**Exhibit B**

**Reliability Standard submitted for Approval**

- 1. Title:** Facility Connection Requirements
- 2. Number:** FAC-001-1
- 3. Purpose:** To avoid adverse impacts on reliability, Transmission Owners and Generator Owners must establish Facility connection and performance requirements.

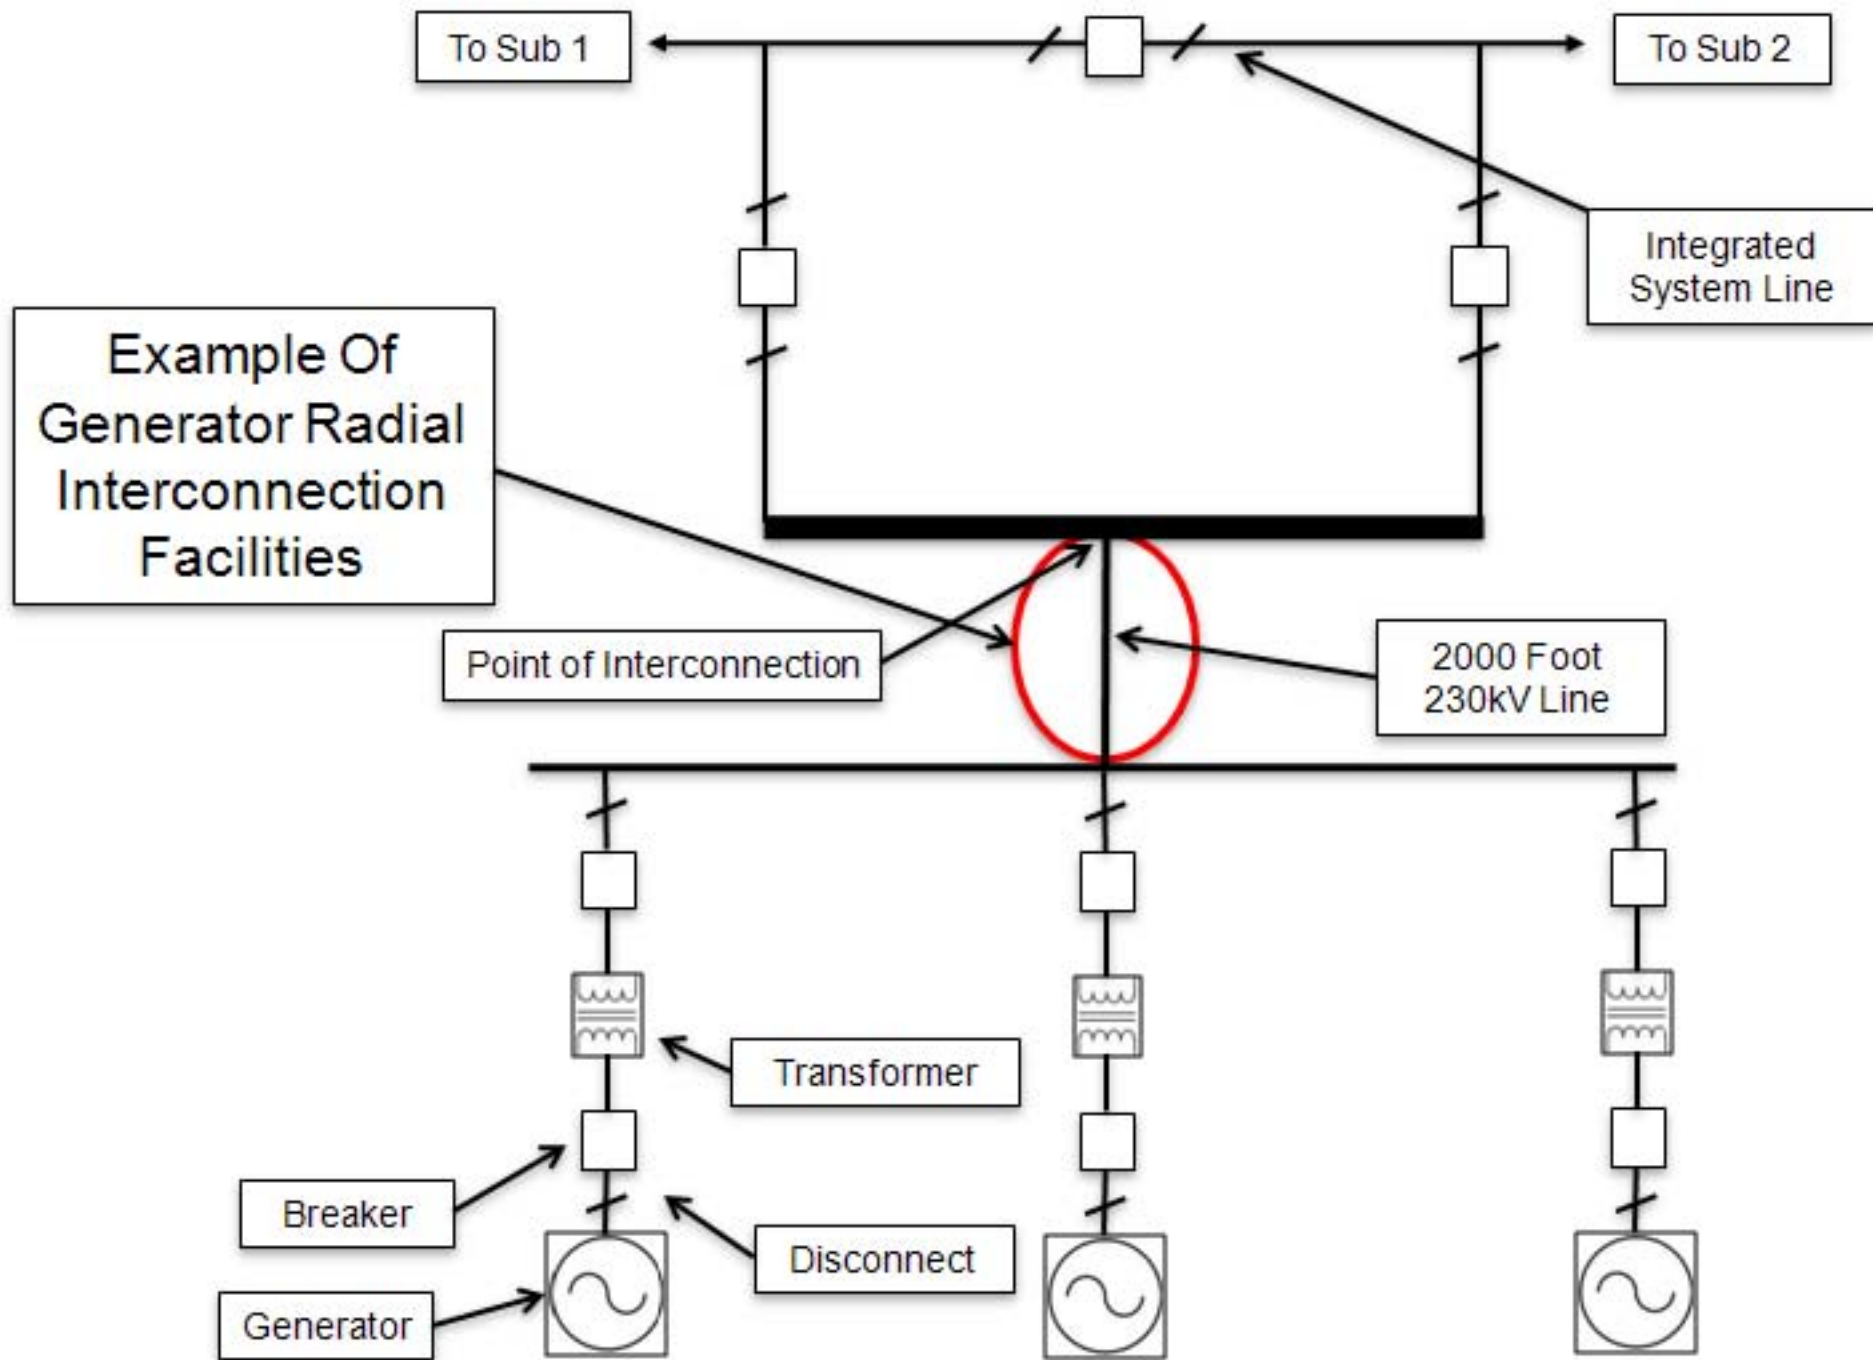
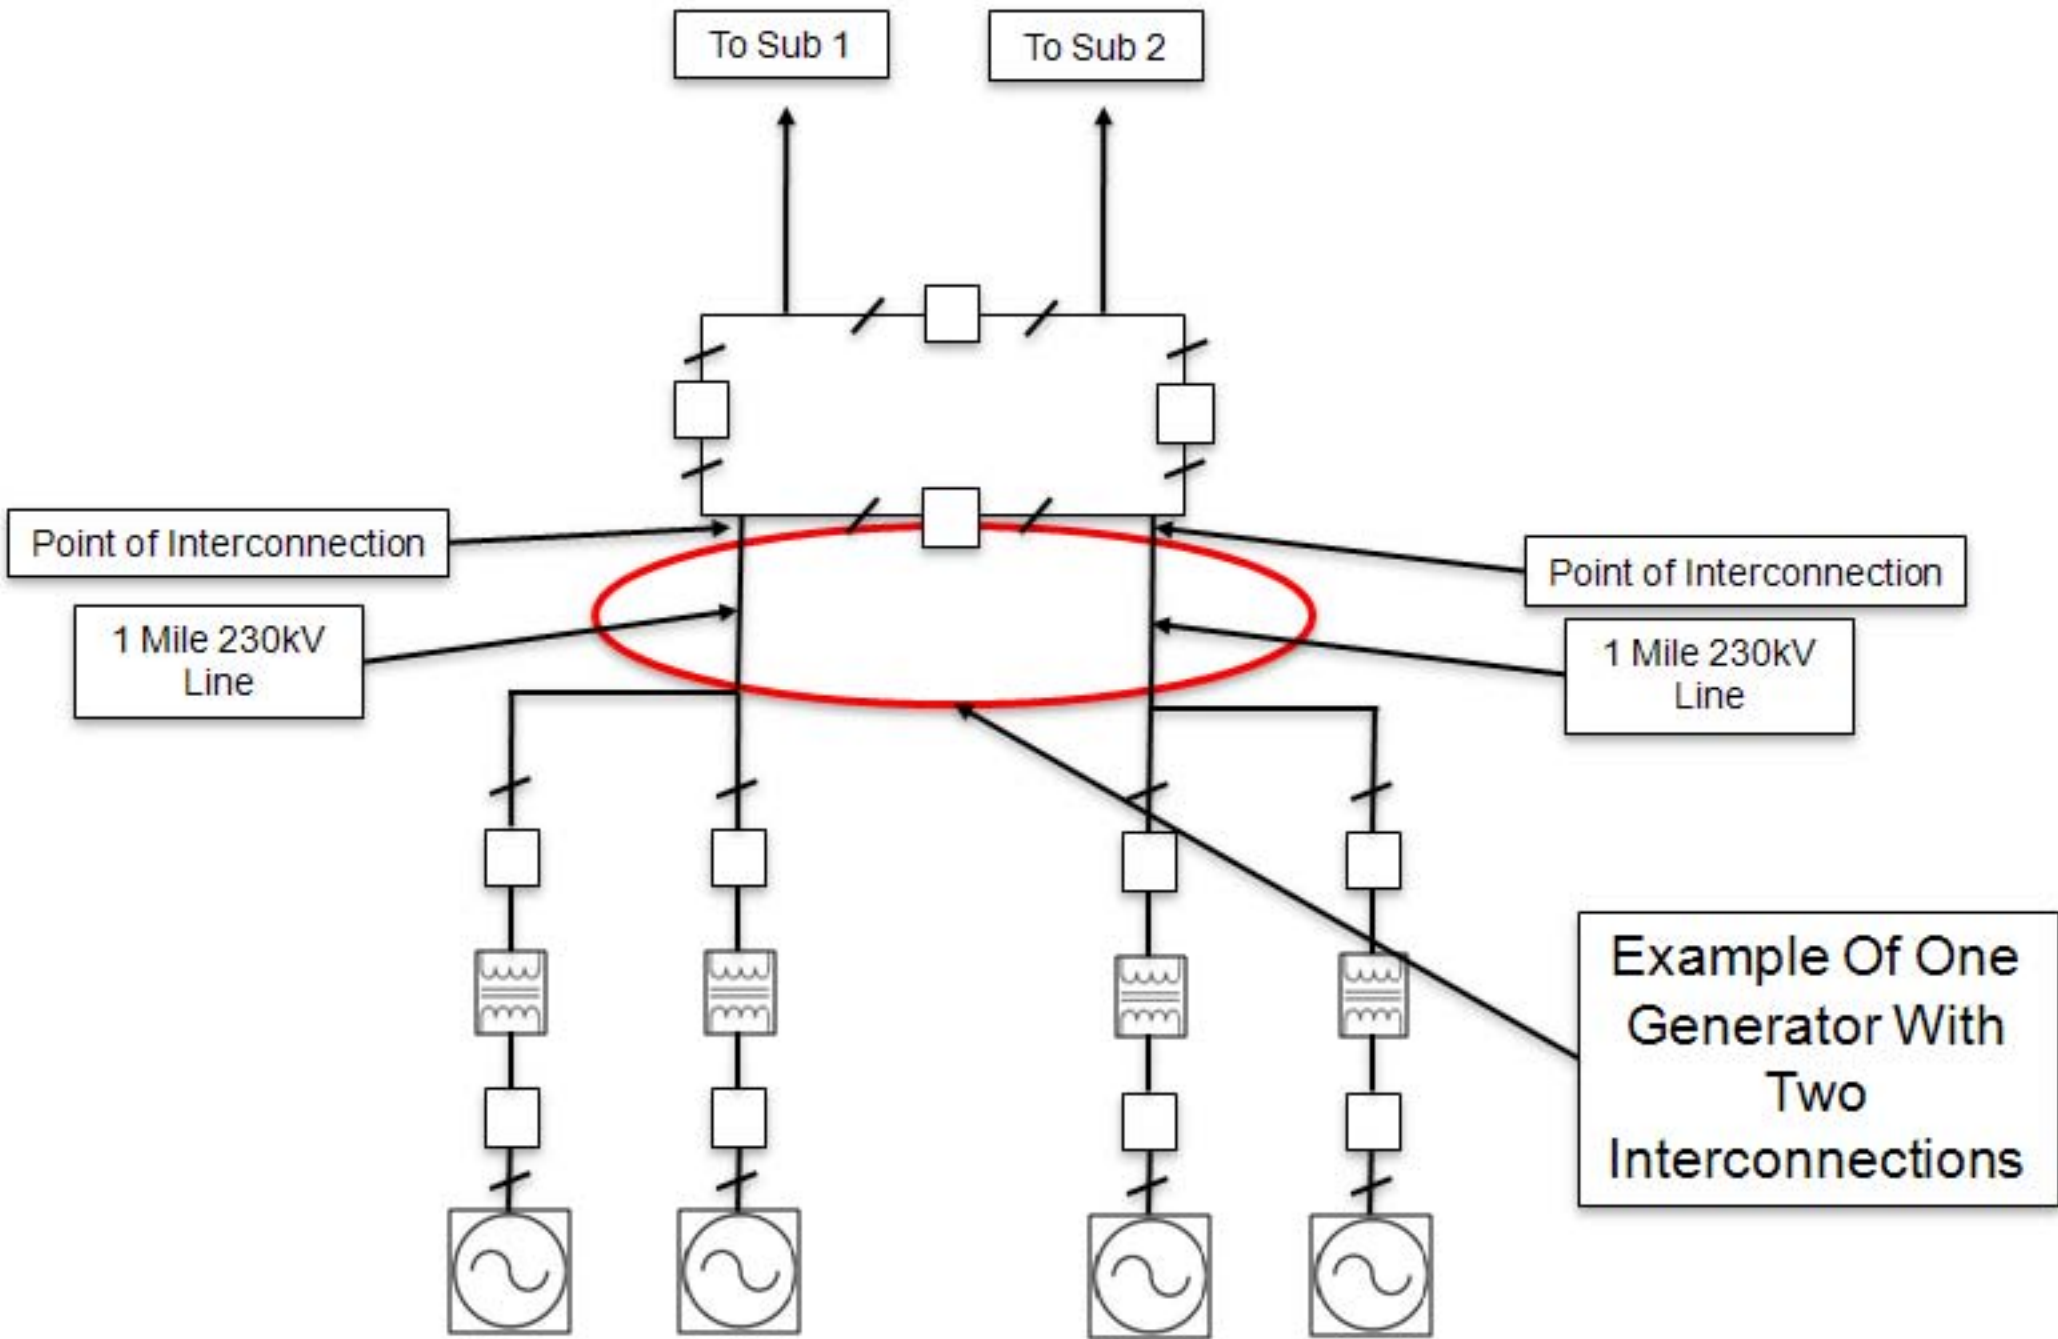
The SDT discussed the various ways such an interconnection could occur and agrees that if the third party interconnection could be accomplished without the need for the existing Generator Owner to develop its own connection requirements and system performance requirements and determine impacts on the interconnected transmission systems, this standard need not apply to the Generator Owner. And the SDT agrees that in many cases, these connection requirements, system performance requirements, and determined impacts on the interconnected transmission systems are currently determined by entities registered as either a Transmission Owner, Transmission Planner, and/or Transmission Service Provider. However, the SDT remains convinced (based on the orders cited above) that there may be occasions where FERC or another regulatory agency compels the Generator Owner to allow a third party to interconnect its planned generator with an existing generator interconnection Facility. Where this occurs, the SDT feels it is necessary for the existing owner of that generator interconnection Facility to provide connection requirements to the third party that requests interconnection. The SDT also believes, and many comments seem to support, that performance requirements and a determination of impact to the interconnected transmission systems need to be evaluated by some entity. The question becomes which entity.

The SDT can only work within the standards development process. We cannot address other regulatory issues such as FERC-mandated open transmission access (Order 888 and subsequent) or state or provincial jurisdiction over generation or transmission assets. While we acknowledge these

mechanisms exists and may come into play in the scenarios described in the proposed FAC-001-1, we as the SDT can only deal within the context of reliability standards. For this reason, R2 indicates that FAC-001-1 applies only when a Generator Owner has an executed Agreement to evaluate the reliability impact of interconnecting a third party Facility to the Generator Owner's existing Facility. The SDT's reasoning here is that if the owner of the existing generator interconnection Facility agrees, or is compelled, to allow a third party to interconnect, and can do so using existing agreements, contracts, and/or tariffs (and thereby avoid having an executed Agreement to evaluate the reliability impact of interconnecting third party Facility to the Generator Owner's existing Facility), and thus avoid having to develop its own connection requirements or perform impact studies, it will. In this example, it is likely that the existing Transmission Owner, Transmission Planner, and/or Transmission Service Provider processes and Agreements will be utilized and the purpose of FAC-001-1 will be met without applying this standard to the Generator Owner.

If, on the other hand, the owner of the existing generator interconnection Facility agrees, or is compelled, to allow a third party to interconnect, but cannot do so without having to develop its own connection requirements or perform impact studies, the SDT believes that the potential for a reliability gap exists. This might occur, for instance, if the owner of an existing generator interconnection Facility was compelled to allow interconnection and to implement open transmission access. In this example, (under FERC Order 888 and subsequent orders), the existing interconnection owner becomes a Transmission Service Provider and is required to have an Open Access Transmission Tariff (OATT). FERC's pro forma OATT requires the Transmission Service Provider to, among other things, perform system impact and feasibility studies. In order to do so, such studies must be coordinated with other Transmission Service Providers and Transmission Planners. And, to further complicate the issue, the SDT has been informed that in Texas, a Generator Owner is not allowed to own transmission.

The SDT does agree with many comments asking that the Generator Owner not be required to maintain its connection requirements, and there was robust discussion among the team and observers. Some were concerned that, without an obligation to maintain, there would not be a review to ensure compliance with NERC Reliability Standards and applicable Regional Entity, subregional, Power Pool, and individual Transmission Owner planning criteria. Others were concerned that the third party requesting interconnection might not actually interconnect, but the owner of the existing generator interconnection Facility would, having executed an evaluation agreement, be forever obligated to maintain connection requirements. In the end, the SDT agreed that if the owner of the existing generator interconnection Facility adopted open access or was determined to be providing “transmission service” it was likely that its existing registration would be re-evaluated and that the issue would be more appropriately addressed at that time. The SDT has therefore agreed to remove maintenance requirements for Generator Owners from both Requirement R2 and Requirement R4 in the proposed FAC-001-1.
